ADDENDUM NO. 1
To Drawings and Specifications for
Elevator Modernization for
Carver Educational Services Center
Montgomery County Public Schools
07 January 2020

- Revised Sheet E1.1, EXISTING/DEMOLITION & PROPOSED FLOOR PLANS, dated 01/07/2020

E1.1

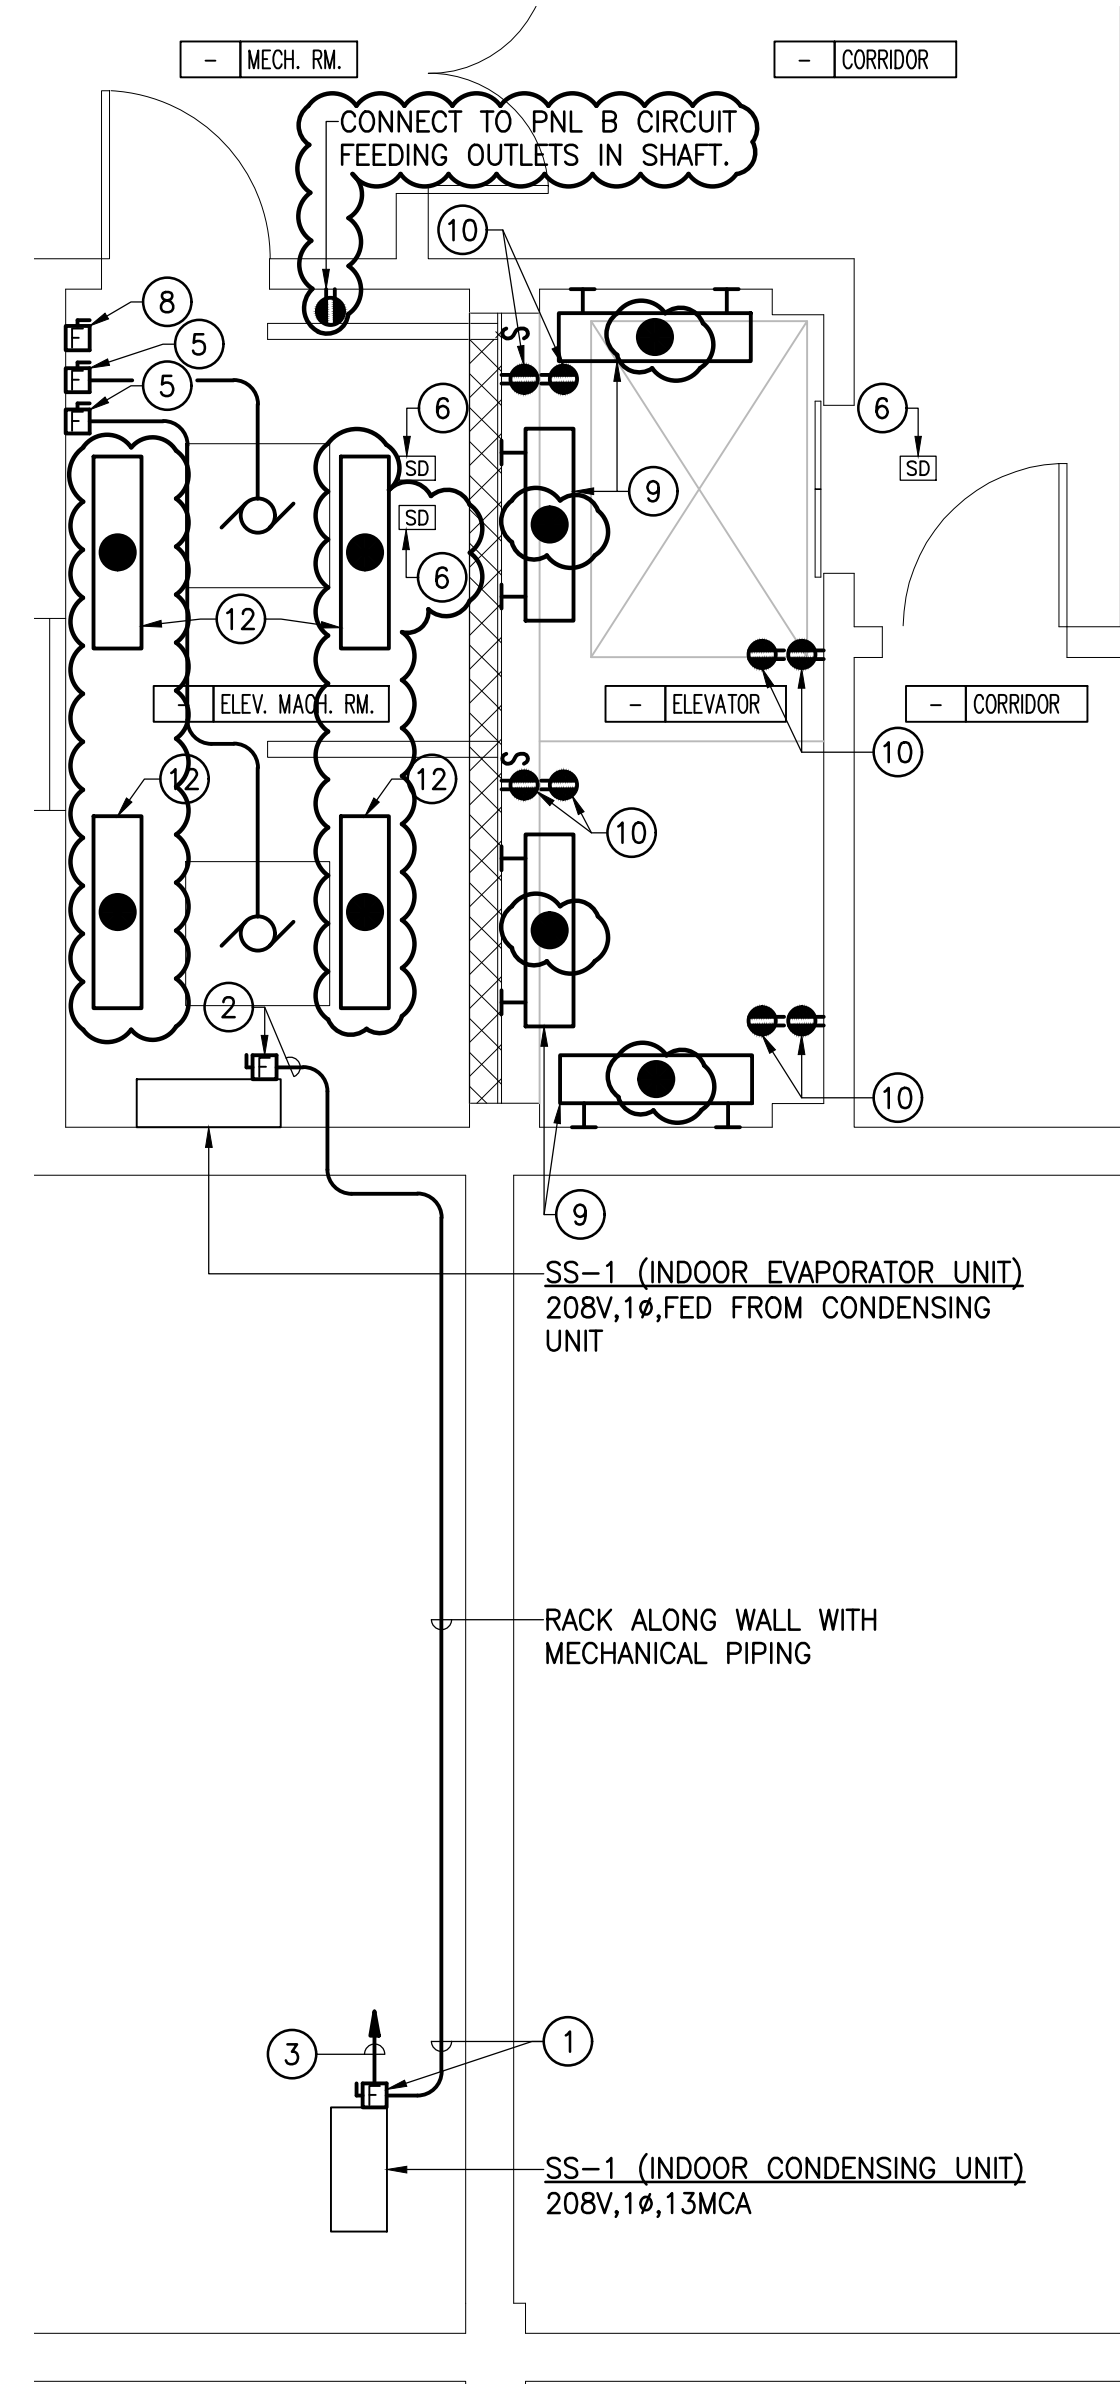
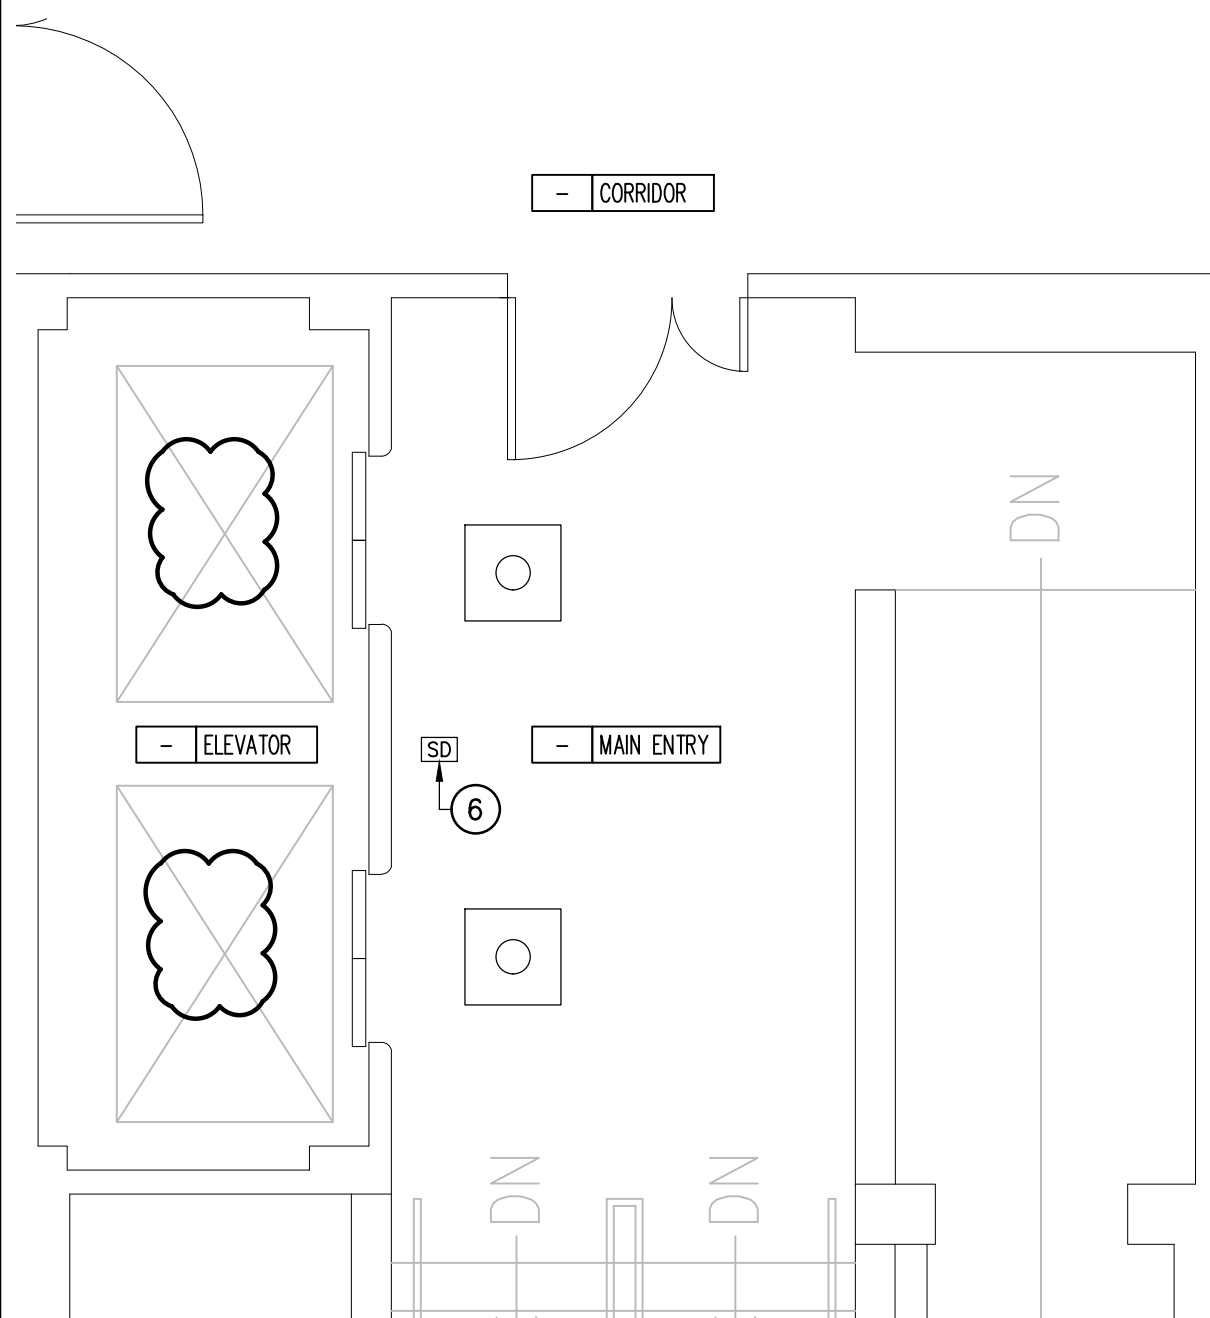
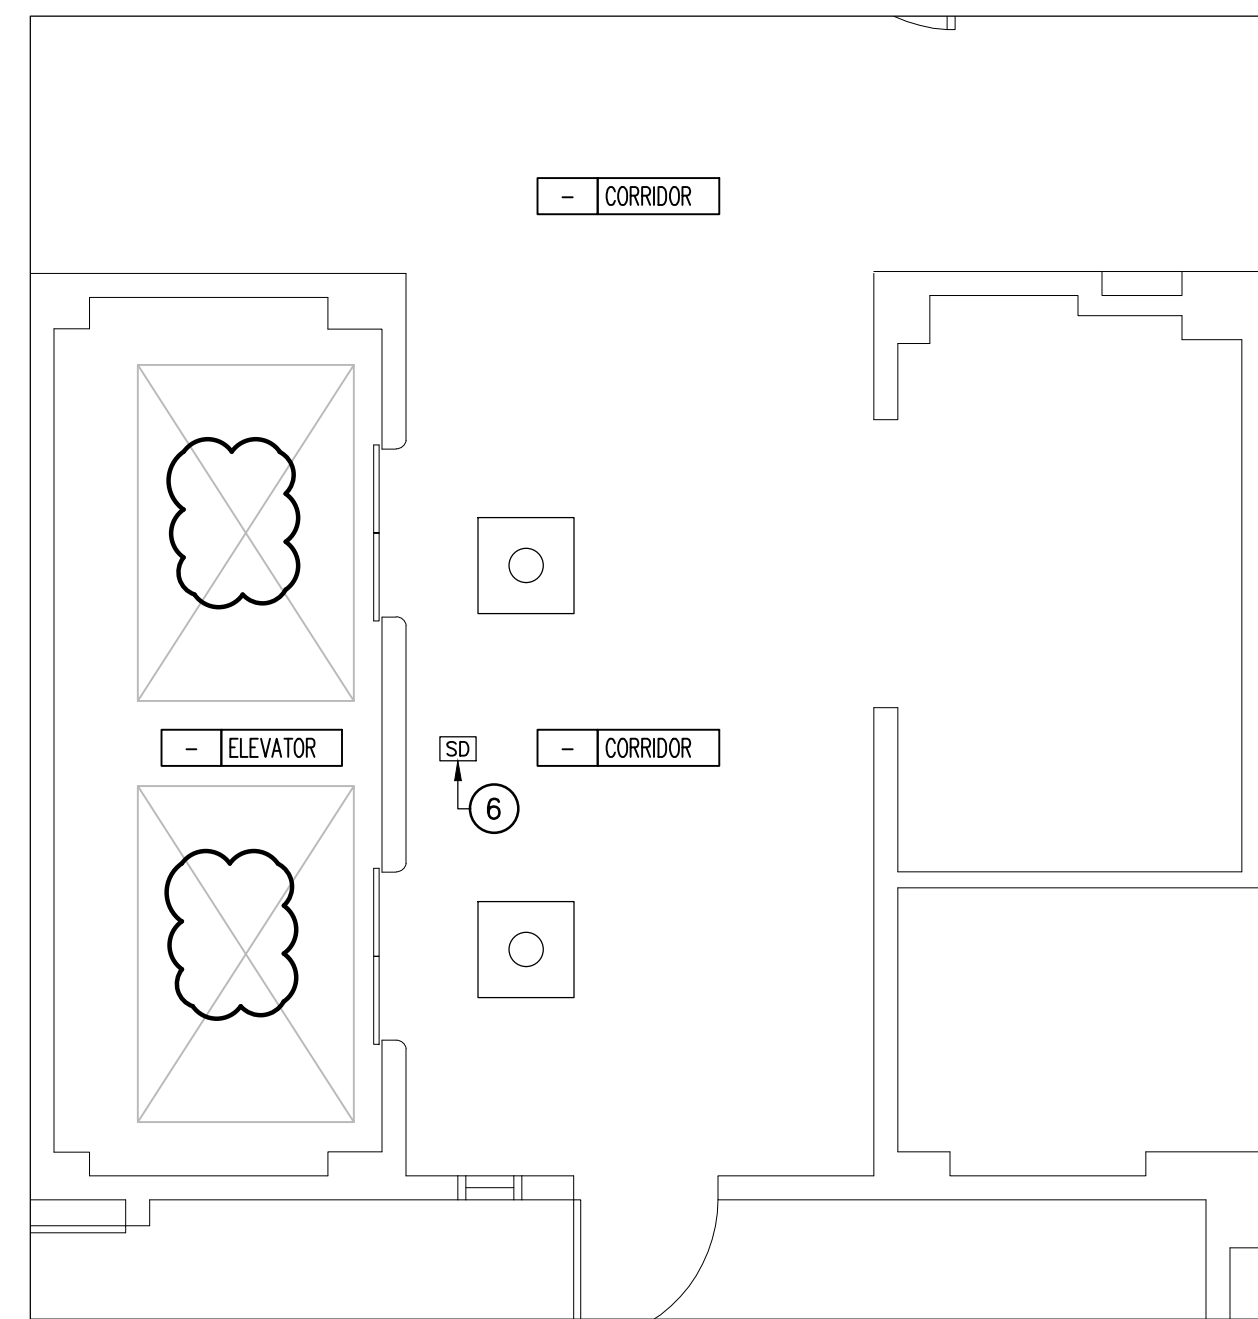
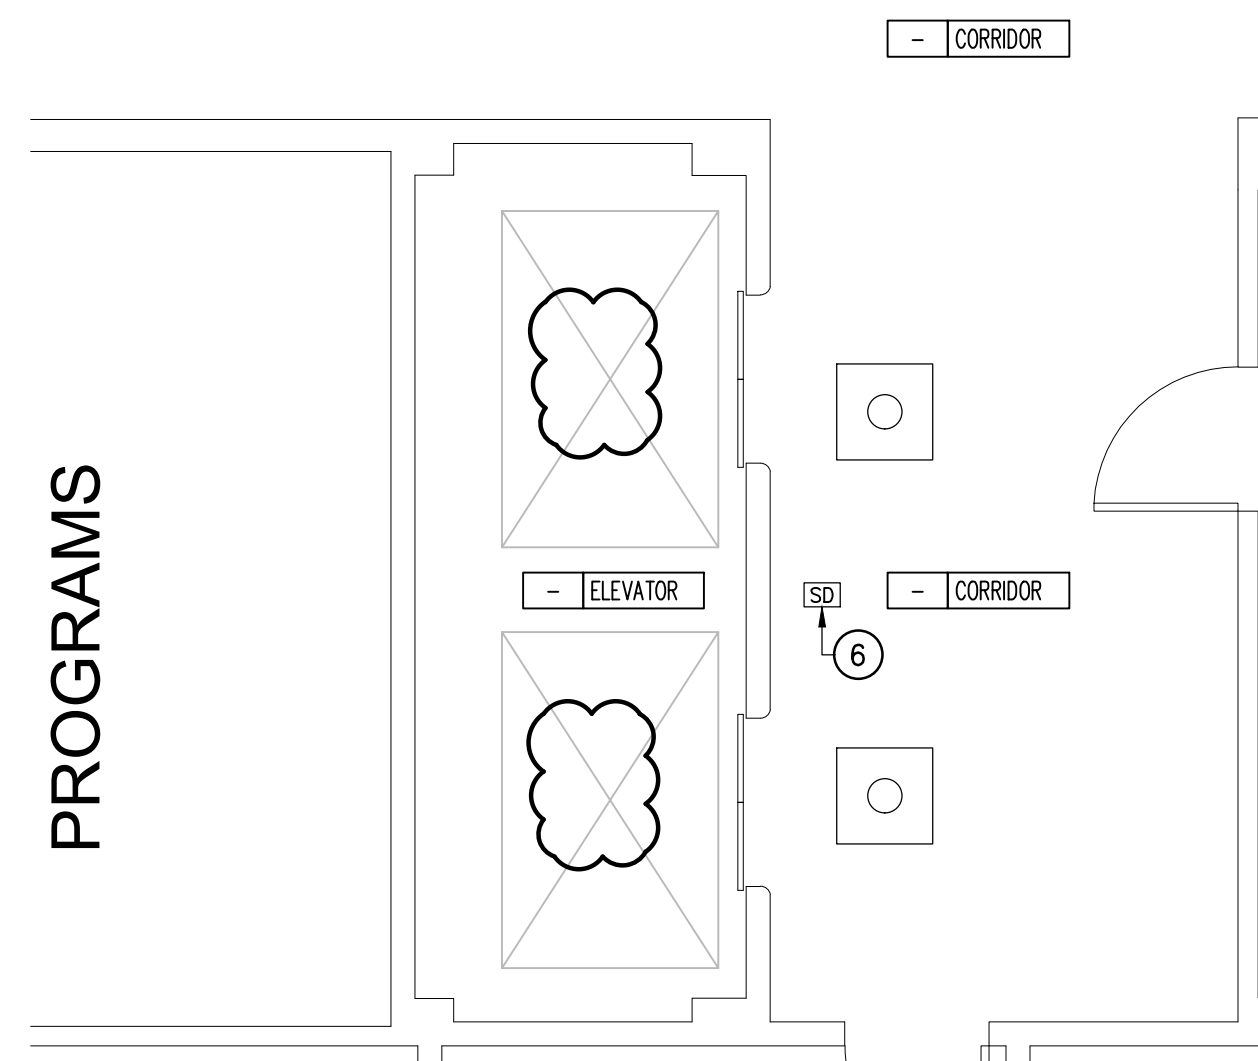
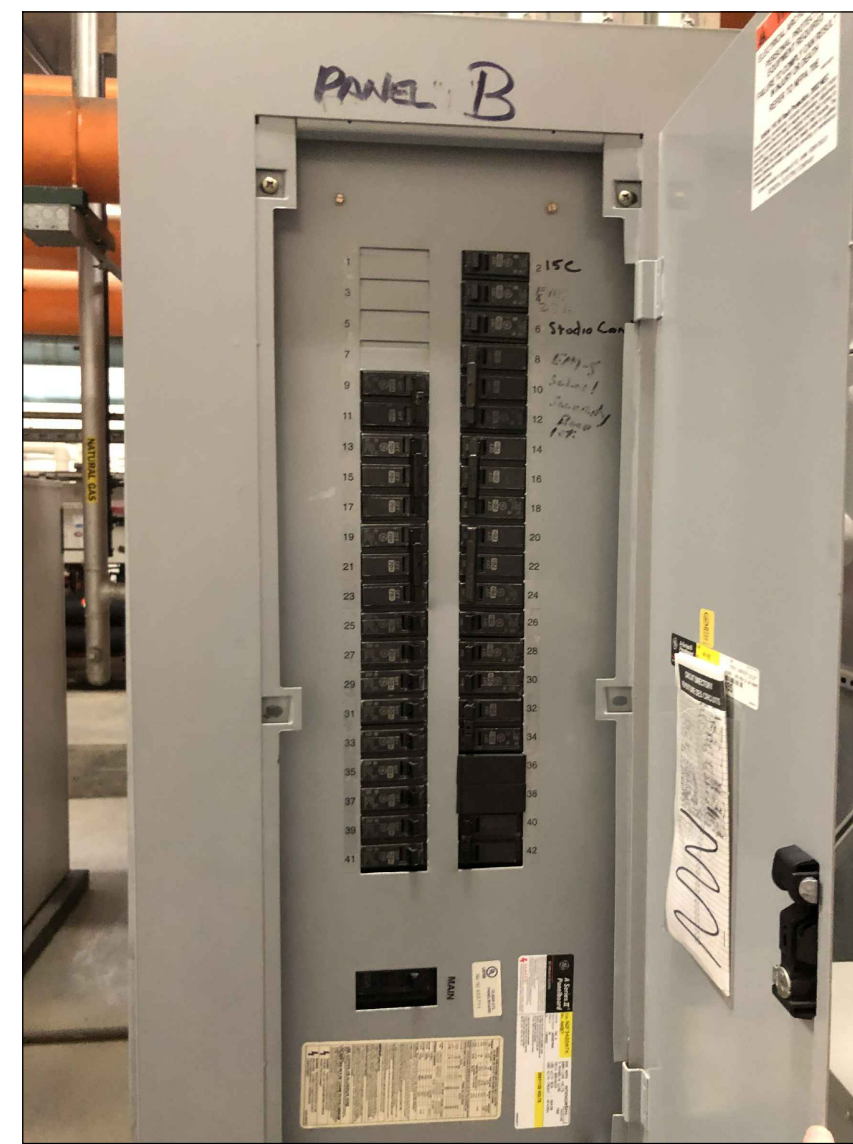
- RFI #01 Is this project subject to prevailing wage/Davis Bacon requirements? If so, please include within the bid documents.
Response: MCPS is to respond.
- RFI #02 Page E1.1 of the drawings shows existing heat detectors within the machine room and elevator shafts. These devices are not existing per field verification. Please advise.
Response: Heat detectors indicated as "existing" can be disregarded, they do not exist.

Response: No sprinkler work is required and shunt trip devices can be removed.
- RFI #04 Adequate elevator machine room lighting is a requirement, but new machine room lighting is not shown. Please advise.

Response: See attached for reissued sheet E1.1, indicating new lighting within the elevator machine room.
- RFI #05 A duplex GFCI receptacle is required within the elevator machine room but is not shown. Please advise.

Response: See attached for reissued sheet E1.1, indicating the receptacle location.
- RFI #06 The existing MDP as shown on page E0.1 of the drawings appears to operate on emergency generator power. Please confirm that the intent is to add these two elevators to the emergency power. If so, all elevator related circuits must also be moved to emergency power to meet code requirements. Please advise how to proceed.

Response: See attached for reissued sheet E1.1, indicating Panelboard B will be used for 120v connections.
- RFI #07 There are no relay modules for the fireman's flashing hat signal within the elevator machine room. This is a code requirement but is not shown. Please advise.

- RFI #15 They show existing machine room lights getting demolished but nothing going back?
Response: See attached for reissued sheet E1.1, indicating new lighting within the elevator machine room.

REVISE The lights in the elevator pit to emergency type as indicated on reissued sheet.

REVISE Drawing Notes 4, 5, 7, and 8, as indicated.

REVISE Heat detector in “Elev. Mach. Rm.” To “SD”

DELETE The heat detectors shown in the elevator shafts.

ADD Drawing Notes 11 and 12, as indicated.

ADD Four emergency lights in “Elev. Mach. Rm.”

ADD GFCI outlet in “Elev. Mach. Rm.” as indicated.
